PowerXL

RAM05/RASP5 Firmware

Firmware Release Note

## 5. Change in Advanced Mode Brake Control (P3-01 = 1)

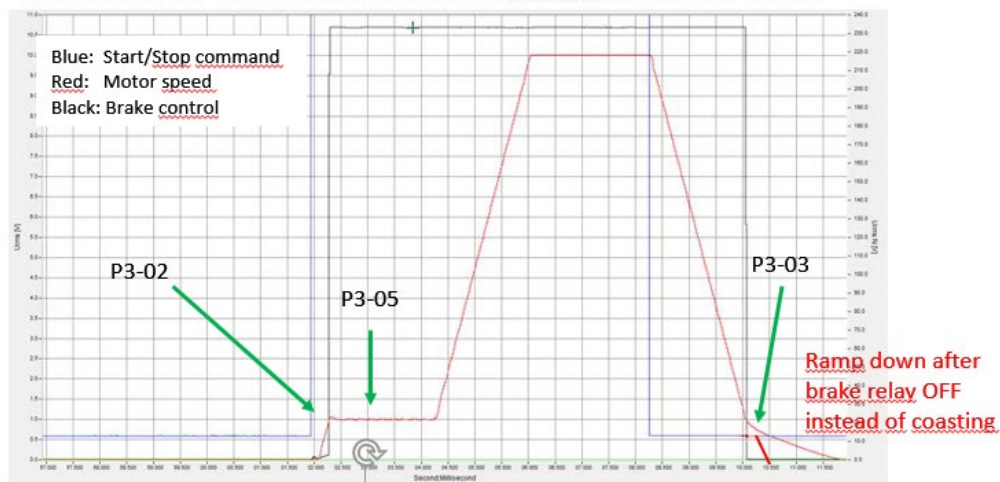
Drive will now ramp to stop (R2S) rather than coast to stop (C2S) after receiving a STOP! Command and arriving at brake apply speed (P3-03)

New FW 1.05: P3-01 = 0 (Simple Mode) and 1 (Advanced Mode Brake Control)

## 6. Added New Advanced Mode 2 Brake Control Option (P3-01 = 2)

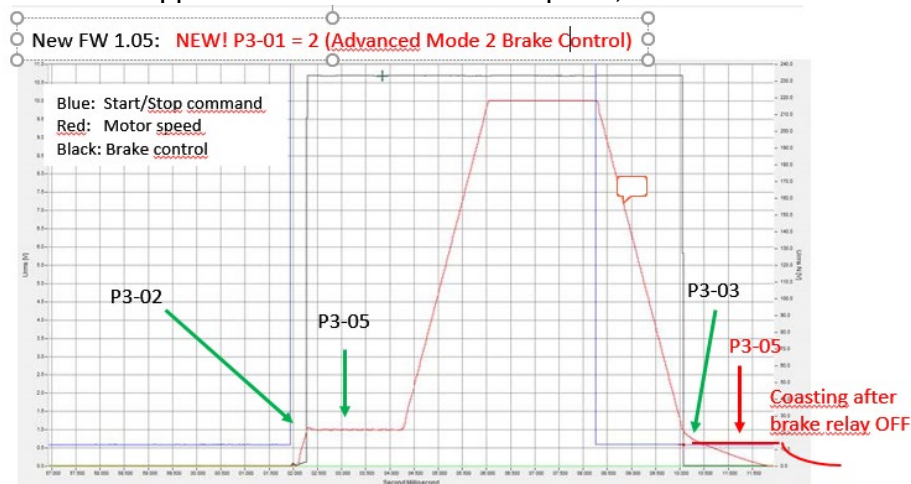
A new option has been added to P3-01 for advanced brake control (P3-01=2).

After receiving a STOP! command, drive will ramp down to Brake Apply Speed (P3-03) and remain at this speed for the time specified on P3-05 waiting for the motor brake to be applied. After this time has expired, drive will coast to stop (C2S).
